Meeting of the Upper Thames River Conservation Authority
Hearing Committee – Agenda
Tuesday March 26, 2024 12:30pm, 1424 Clarke Rd. London

Proposed Development within a Riverine Flood Hazard Area Regulated by the Upper Thames River Conservation Authority at 49 Blackburn Crescent, Municipality of Middlesex Centre (Komoka), Ontario

To: Chair and Members of the UTRCA Hearing Committee
From: Cari Ramsey, Land Use Regulations Officer
Date: March 13, 2024
File Number: HC-03-24-02
Agenda Number: 5
Subject: Section 28 Permit Application #33-24 for Proposed Development within a Riverine Flood Hazard Area Regulated by the Upper Thames River Conservation Authority at 49 Blackburn Crescent, Municipality of Middlesex Centre (Komoka), Ontario

Attachment #4 – UTRCA 2024 floodplain mapping

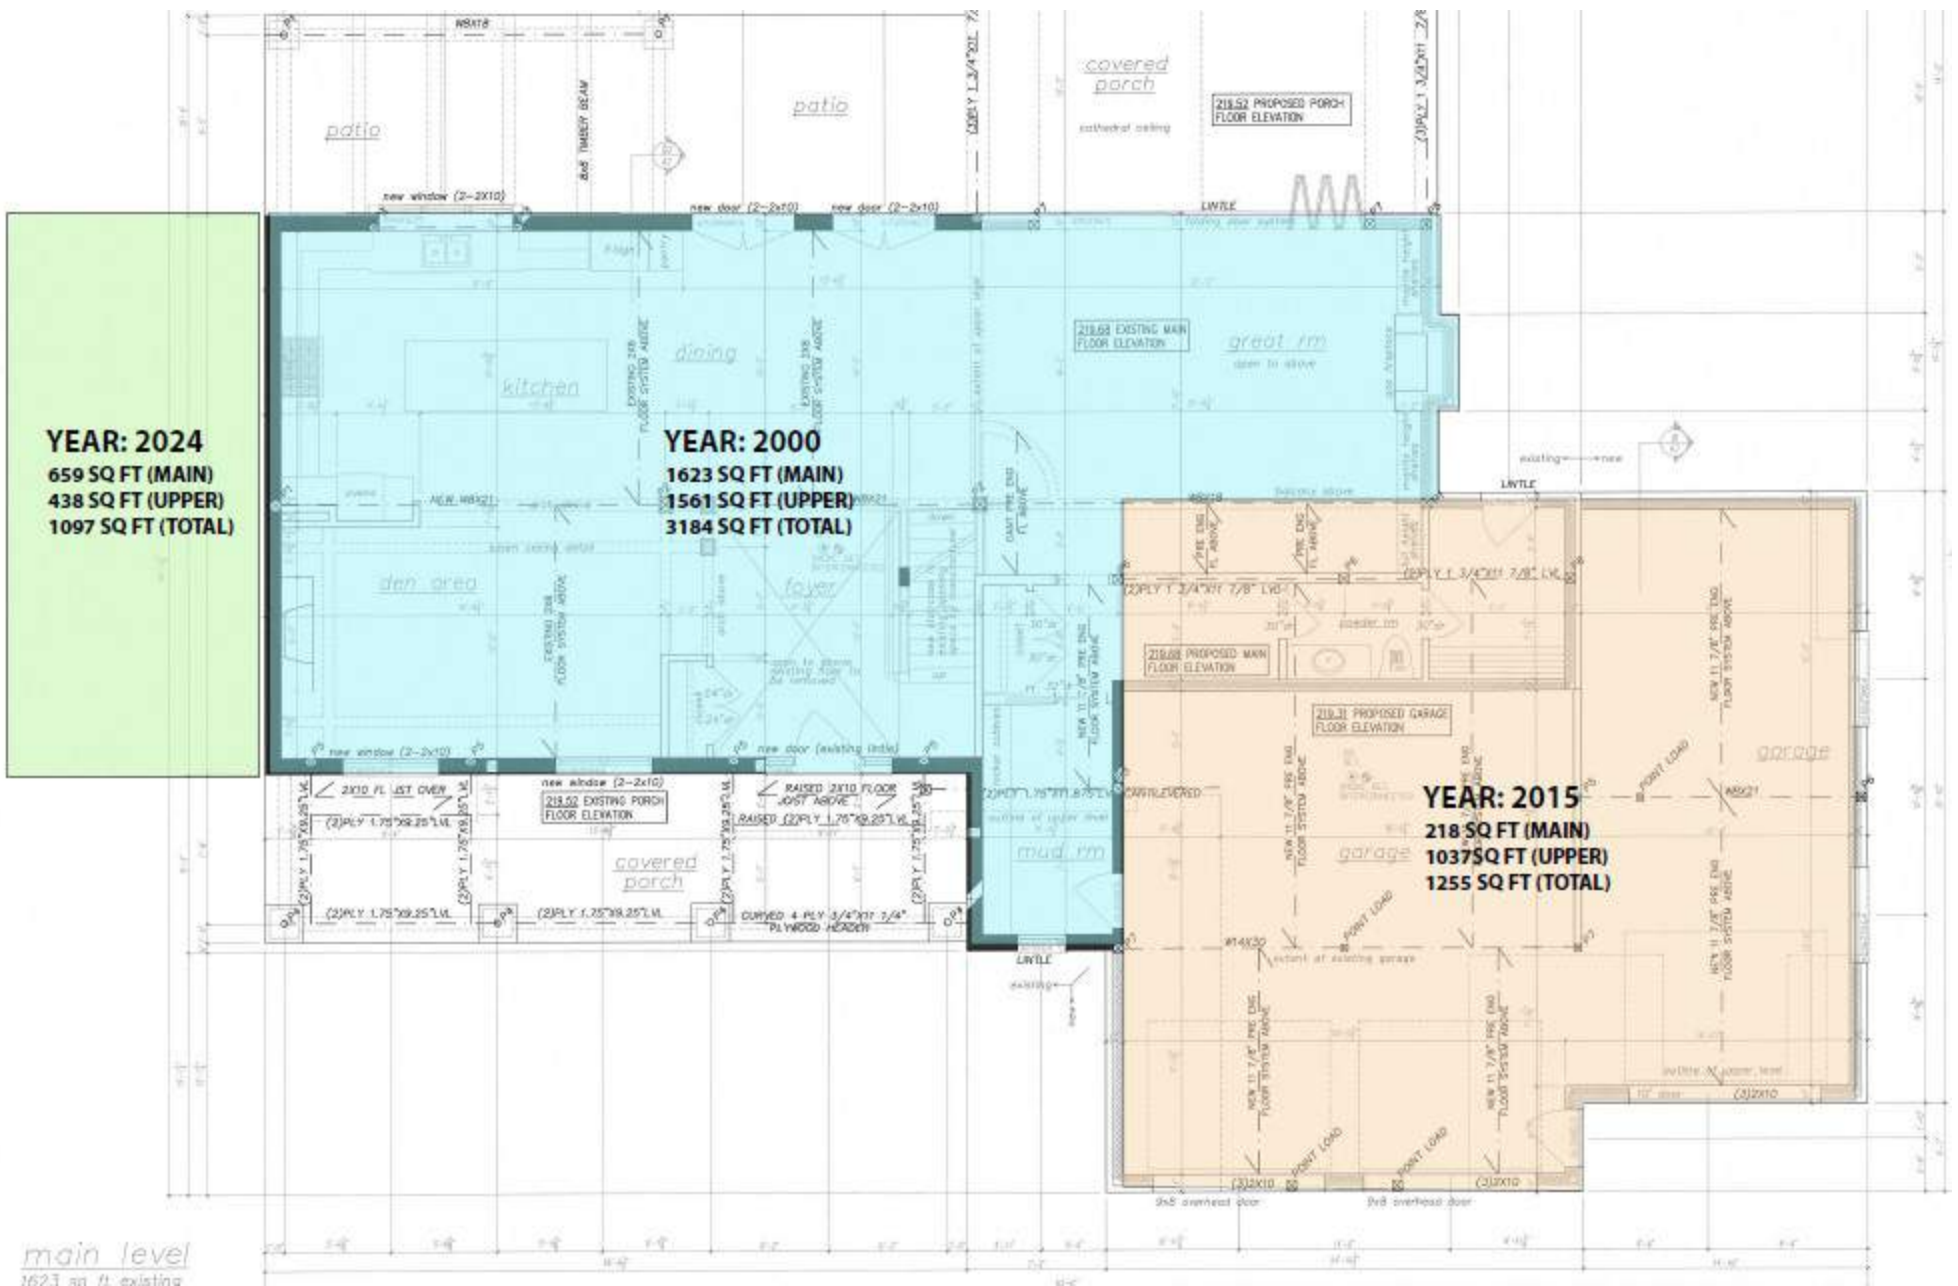
According to current elevation information and flood modeling, the flood depths on the property during a Regulatory (1:250 Year) Flood Event would be estimated to range from a depth of 3.5 metres at the rear of the property to approximately 1.5 metres at the front of the property. According to current flood modeling, the road would overtop in a Regulatory Flood event (potentially to a depth of more than a metre), cutting off flood free access to the lot.

The property at this address falls entirely within an area impacted by the floodplain of the Thames River. Due to the extent of the floodplain (**Attachment 4**), this property lies entirely within the flood hazard and does not have what would be considered "safe/dry access" according to current provincial technical standards (*Ontario Ministry of Natural Resources (OMNR) River and Stream Systems: Flooding Hazard Limit, Technical Guide, 2002*) and UTRCA flood hazard policies. For a scenario such as this (no provision for safe and/or dry access), the accepted UTRCA standard has been that new additions of greater than 25% of the original house size (as it existed on April 25, 2000) would not be supported. The residence and garage already acquired a previous addition greater than the 25% within the last 10 years.

As of 2023, UTRCA engineering staff had a more accurate floodline available due to updated survey and hydraulic modelling information which showed that the flood plain had a far greater reach than initially modelled (**Attachment #4**) and verified that there is no safe or dry access into the property. C. Ramsey informed the applicant that since an addition has already been constructed in the floodplain, and given there is no provision for safe/dry access, any additional increase in size could not be approved at a staff level. The applicant was further advised that they were welcome to apply for a Hearing before the UTRCA Hearing Committee for review. It was also discussed that should they choose to request a hearing, any plans submitted as part of their application would need to confirm how the addition could be floodproofed to an elevation of 220.5 metres geodetic. If floodproofing to 220.5 metres geodetic would not be technically feasible, then any plans submitted would have to show the elevation to which the addition could be floodproofed.

encl. Figure A - preliminary layout plan
Test pit and particle-size distribution information

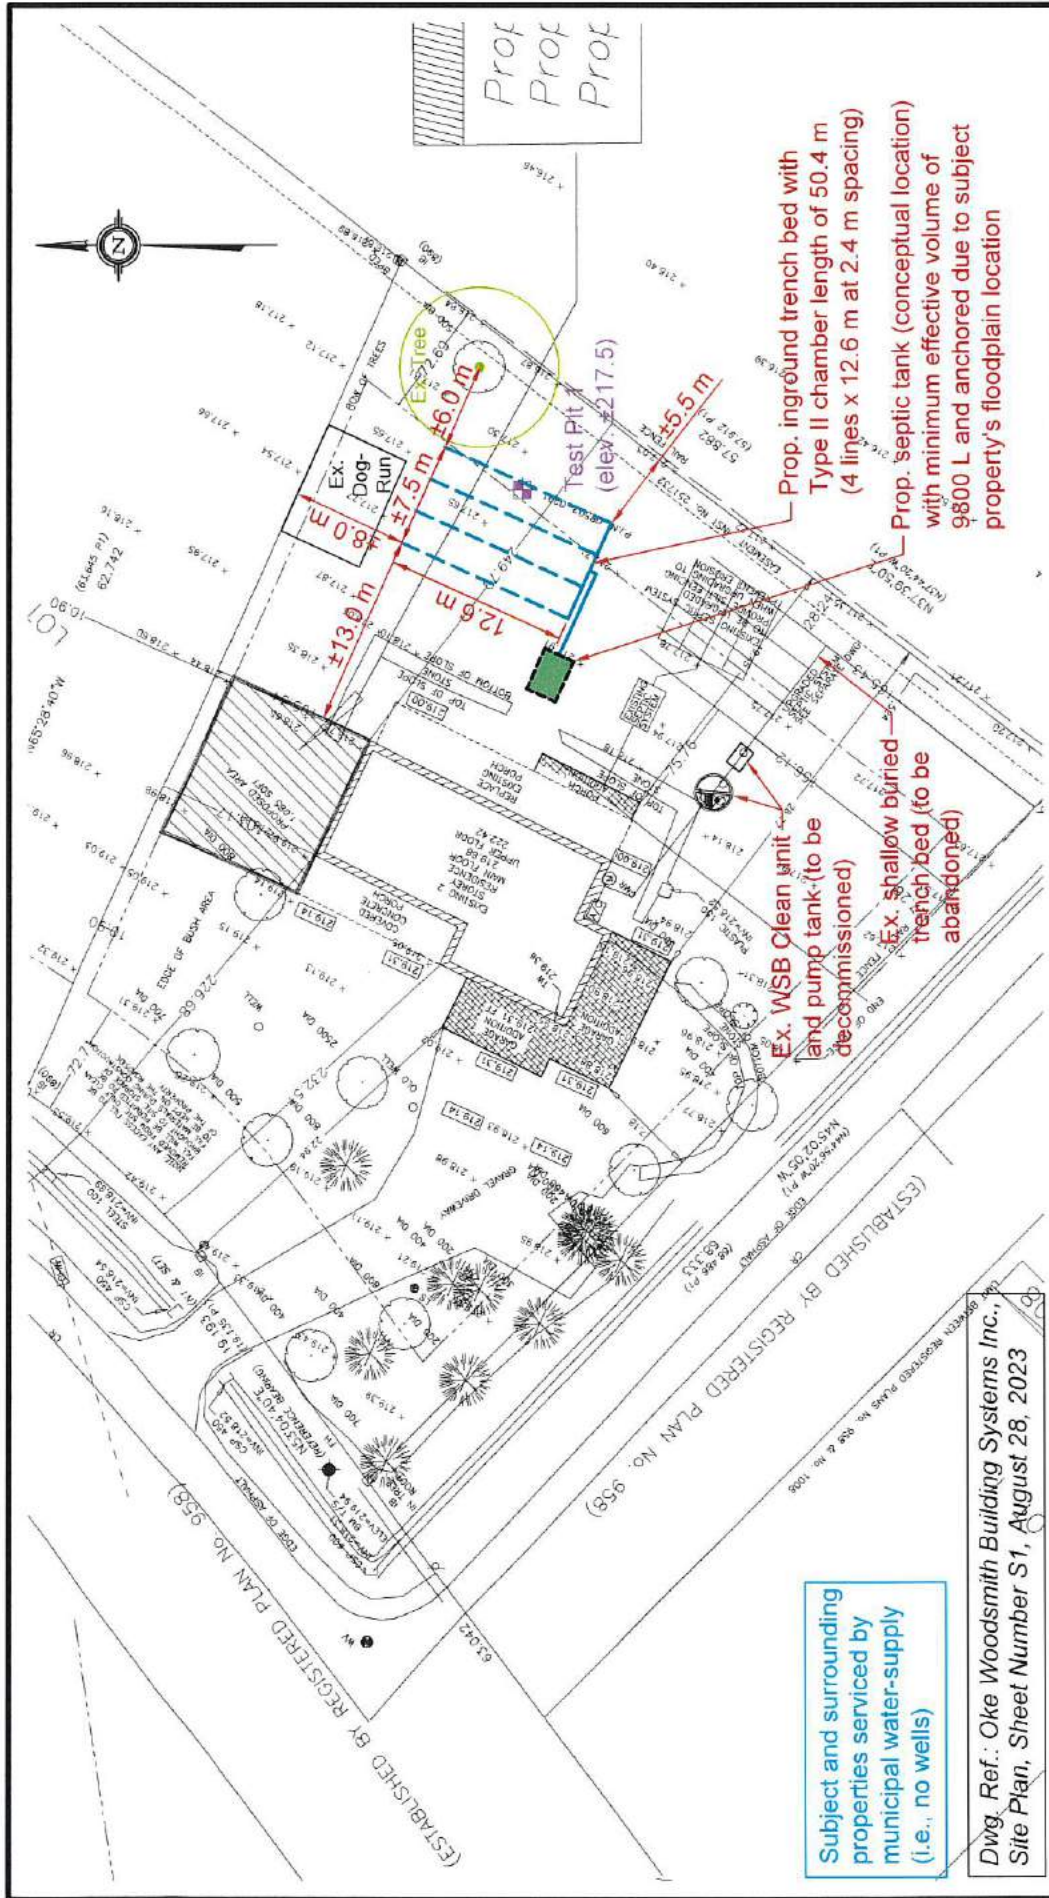
The new system is recommended to consist of a septic tank (with a minimum effective volume of 9800 L) and an inground trench bed with a total Type II chamber length of 50.4 m. A preliminary layout of the bed is illustrated on Figure A to demonstrate spatial feasibility.

The preliminary system layout illustrated on Figure A demonstrates compliance with the OBC’s minimum capacity requirement, as well as the OBC’s minimum required clearances.

Of note, the septic tank location is yet to be confirmed, and is therefore shown conceptually on Figure A; a specific location will be illustrated in future detailed design documents. The property’s location within the regulatory floodplain of the Thames River requires the septic tank to be anchored in accordance with OBC Sentence 8.2.2.2.(7).

Sheet No.
A1
SCALE: 3/8"=1'-0"

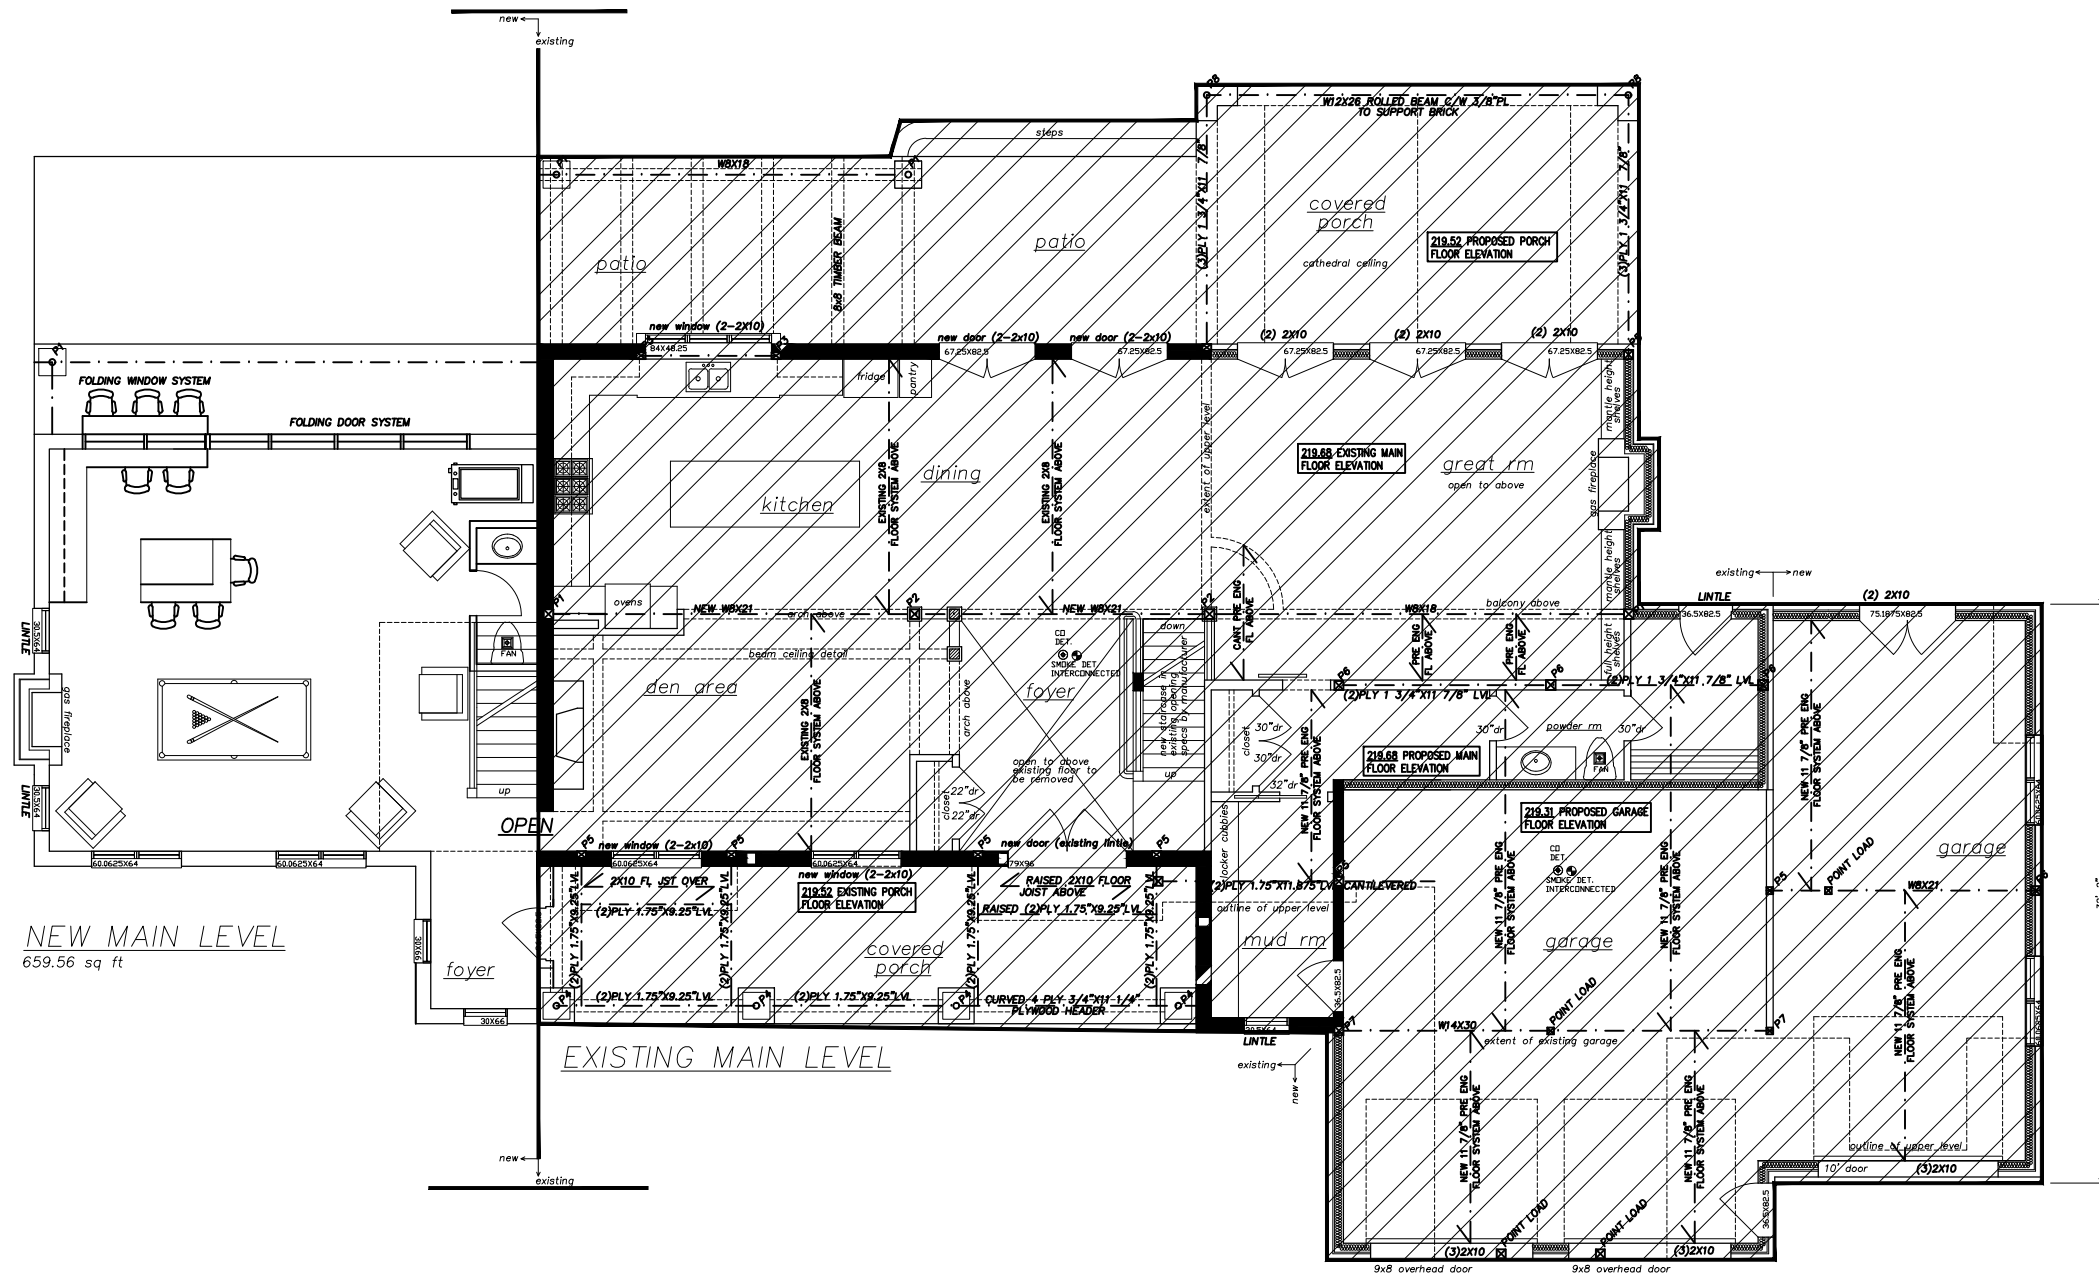
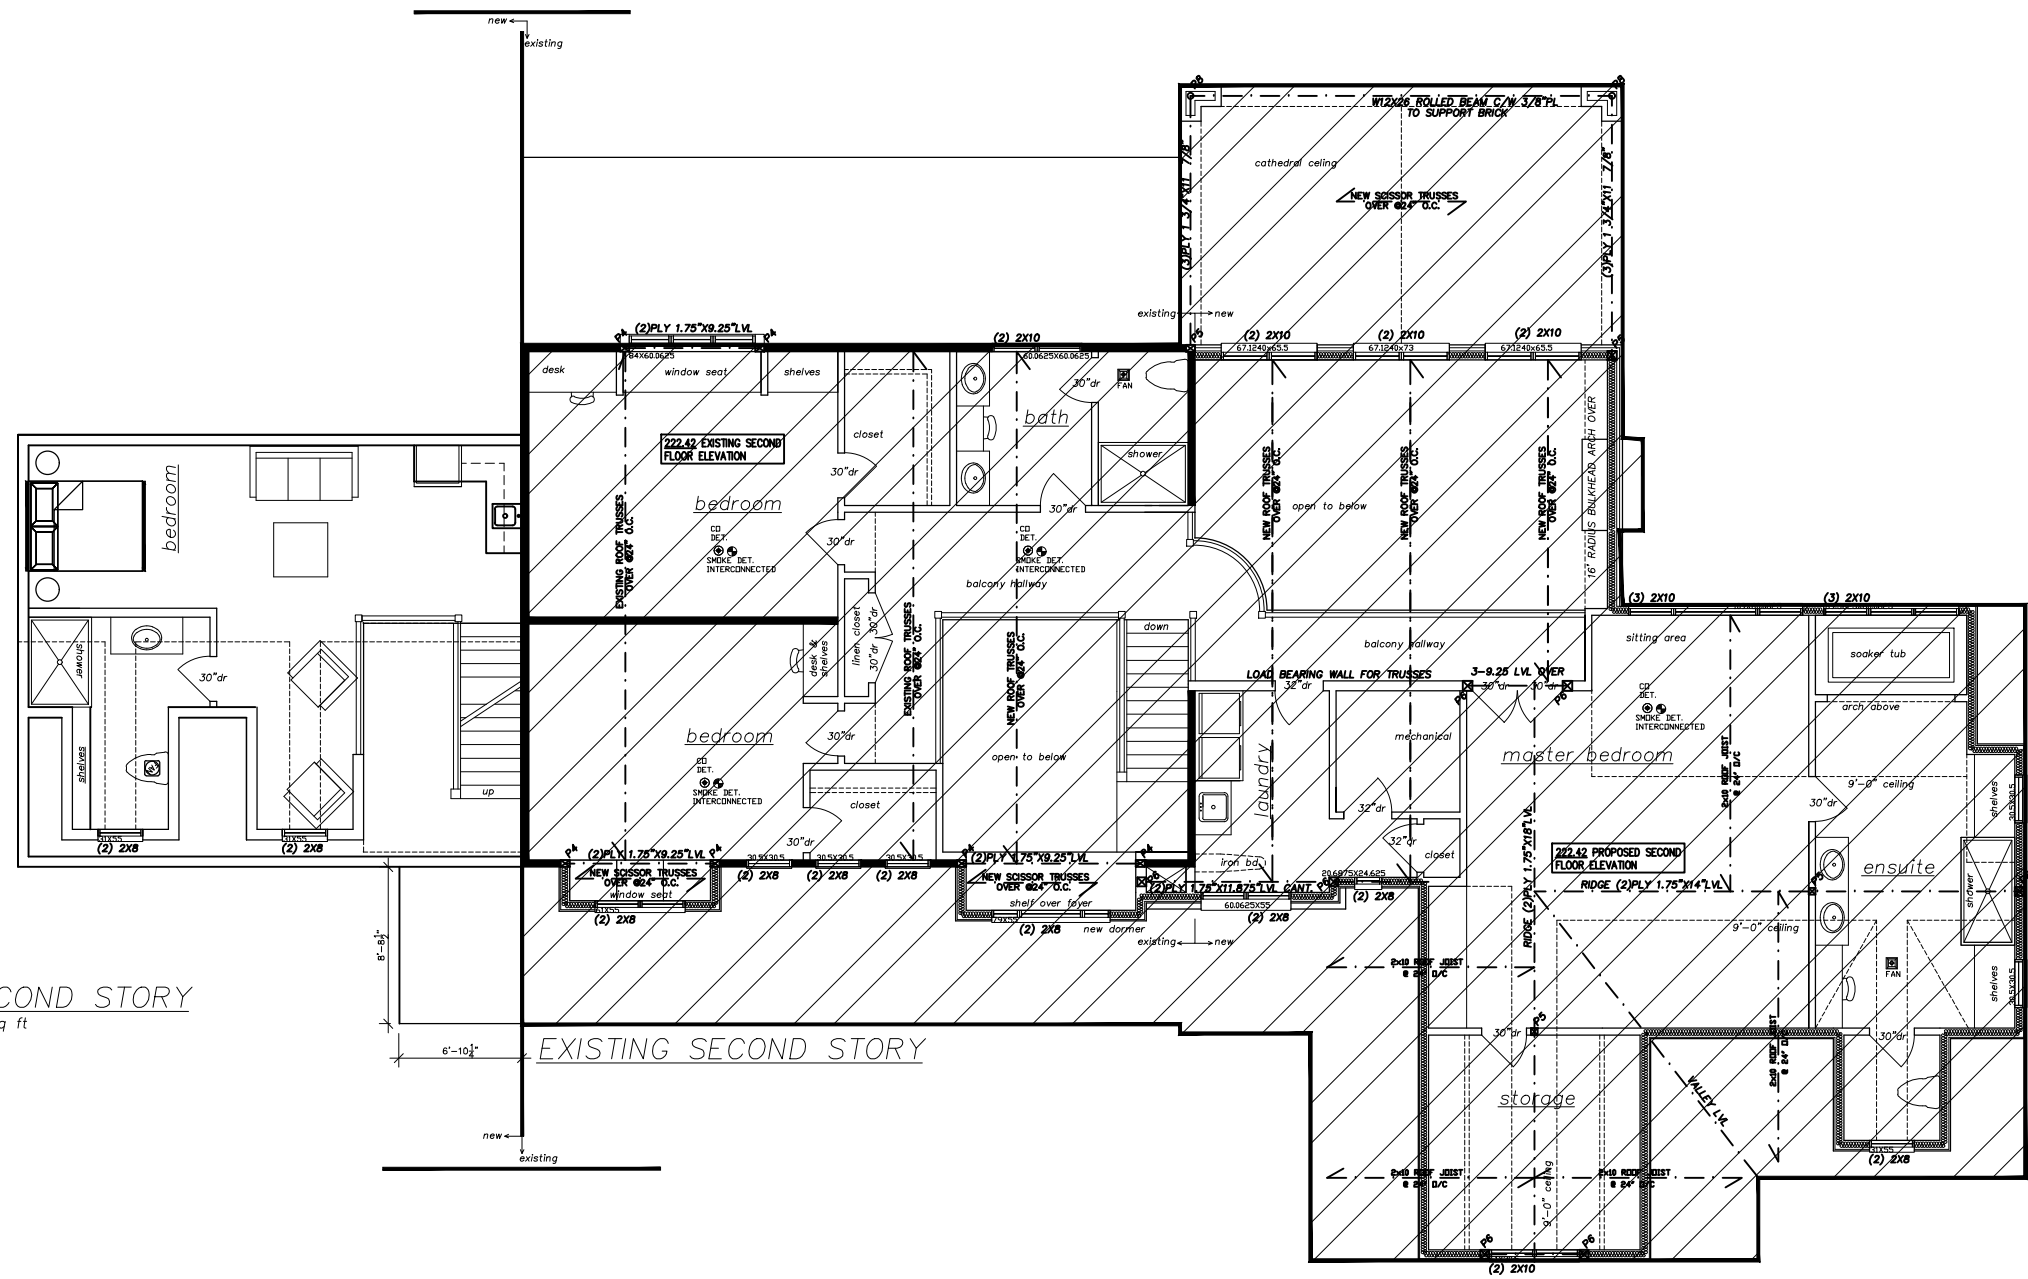
The addition for 49 Blackburn Crescent as currently proposed:

- Will be larger than 25% of the structure as it existed in April of 2000.
- Does not have flood-free access.
- Contains one opening below the level of the Regulatory Flood Elevation. Generally, the UTRCA does not permit new openings (windows, doors, servicing vents) below the level

of the floodproofing elevation. However, they have advised that the proposed door is a floodproofing door made to withstand hydraulic pressures.
